SERVICE BULLETIN 99-06-01

Date Released:	October 21, 2021 October 21, 2021 (Rev 2, made SB mandatory; removed the original option for ongoing inspections) June 30th, 1999 (Rev 1)
Date Effective:	October 21, 2021
Subject:	Overhead (“suspended”) rudder pedals for the RV-6 and RV-6A are cracking and need to be replaced <u>or</u> reinforcement gussets need to be installed
Affected Models:	RV-6, RV-6A
Required Action:	Replace or reenforce all affected WD-655-L/R rudder pedals with gussets
Time of Compliance:	Before further flight
Supersedes Notice:	Revises and replaces SB 99-06-01 Rev 1
Labor Required:	6.0 Hours (Note this number is highly dependent on the configuration of the RV-6, the presence of a center console, or other unique features that may inhibit the removal and subsequent installation of WD-655-L/R)
Level of Certification:	Check the rules of the local controlling authority/agency and the operating limitations for your aircraft

FIGURE 1: GUSSET DETAIL

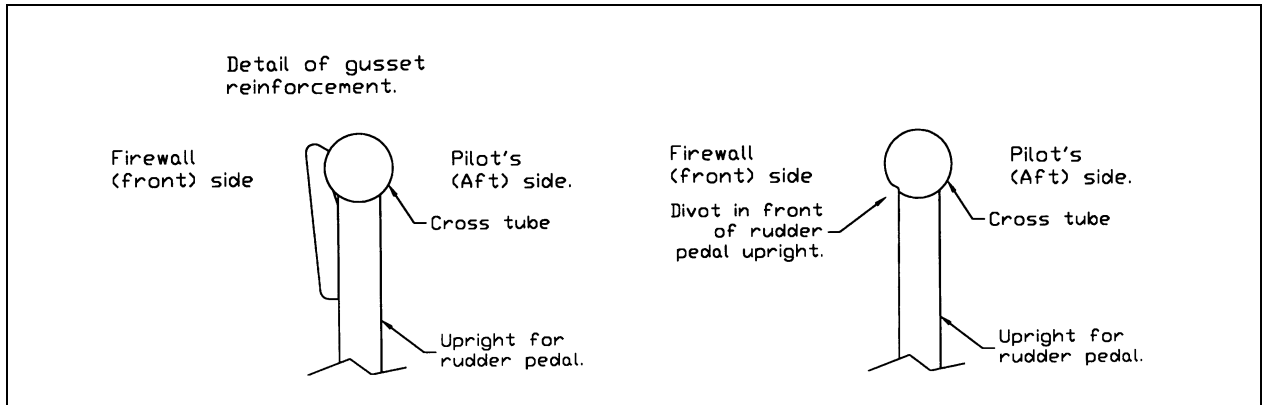
There have been several cases of welds breaking on the overhead-style rudder pedals (WD-655L and WD-655R) used in the RV-6/6A. These breaks usually occur where the upright tubes from the pedal connect to the torque tube that runs across the fuselage. The forward side of the torque tube fails in compression, allowing the aft side of the torque tube to tear.

Step 1: Check that your rudder pedals have gussets installed, as shown in Figure 1. Also refer to KAI drawing 43A.

Step 2: If no gussets are present, remove the WD-655-L/R Rudder Pedals from the aircraft. Reference KAI drawing 43A.

Van's Aircraft, Inc. will make available, free of charge, a set of finger patches that may be welded on the pedals. The part number for a kit containing eight patches and instructions is: WD-655 FPKIT.

Step 3: Repair or replace the pedals using one of the methods described in the materials required section, above.
